**SUNDRY NOTICES AND REPORTS ON WELLS**

1. Type of Well					
Oil Well Gas V	Well Other	MAY 2 5 2012		8. Well Name and No Gaucho Unit 7	
2 Name of Operator Devon Energy Production Company	y, L.P. /	9. API Well No 30-025-34440			
3a Address 20 N Broadway, Oklahoma City, OK 73102-82	60 3t	10 Field and Pool or Exploratory Area OJO CHISO			
4 Location of Well (Footage, Sec. T NESW, 1650 FSL & 1980 FWL SEC.	R,M, or Survey Description) 7 T228 R34E	11 Country or Parish, State Lea County, NM			
12 CHEC	CK THE APPROPRIATE BOX(	ES) TO INDICATE NATUR	RE OF NOTIO	CE, REPORT OR OTHE	ER DATA
TYPE OF SUBMISSION	TYPE OF ACTION				
Notice of Intent	Acidize	Deepen	Prod	uction (Start/Resume)	Water Shut-Off
Notice of Intent	Alter Casing	Fracture Treat	Recl	amation	Well Integrity
Subsequent Report	Casing Repair	New Construction	Reco	mplete	Other
Suosequent Report	Change Plans	Plug and Abandon	<b>✓</b> Tem	porarily Abandon	
Final Abandonment Notice	Convert to Injection	✓ Plug Back		er Disposal

NM-92781: Gaucho Unit #7 Plug Back API: 30-025-34440 Lea County, New Mexico

See attached wellbore diagram.

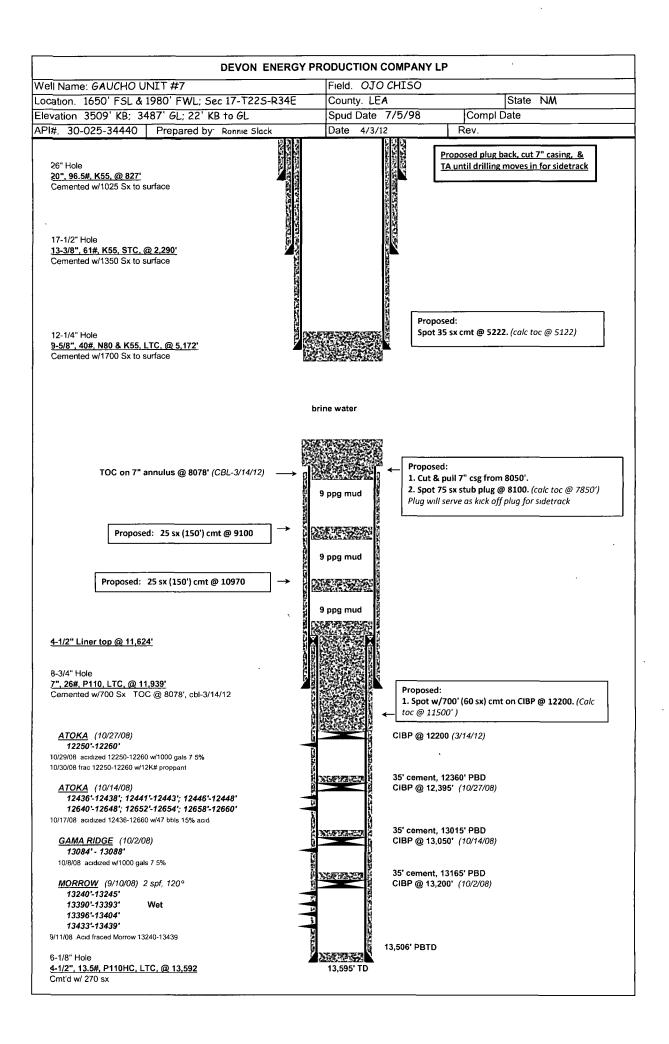
## Based on current wellbore diagram submitted (plugs to be Class H due to depth)

- 4. CIBP set @ 13,395' with 35' cement current PBTD @ approx.. 12,360 Operator to tag current PBTD and confirm 35' of cement.
- 5. Operator to RIH and set CIBP at 12,200' (Atoka open perfs @ 12,250-12,260')

- 6. As per step1 procedure on sundry Operator to Tag @ 11,500' or shallower (TAG to be witness by BLM)
- 7. As per sundry wellbore diagram: Spot 150' cement plug @ 10,970' tag at 10,820 or shallower (Wolfcamp)

- 8. As per sundry wellbore diagram: Spot 150' cement plug @ 9,100' tag at 8,950' or shallower (Bone Spring)
- 9. Continue on as per sundry steps 2 to 6 pulling 7"casing and tag Casing stub plug at approximately 7920 or shallower. (TAG to be witness by BLM)

- 10. Note: no more than 2000' is to be allowed between cement plugs in open hole!!
- 11. Cement plug at 9-5/8" csg shoe will be from <u>5920' to 5122'</u> Due to 2000' minimum between plugs (TAG to be witness by BLM). (Plugs can be Class C)
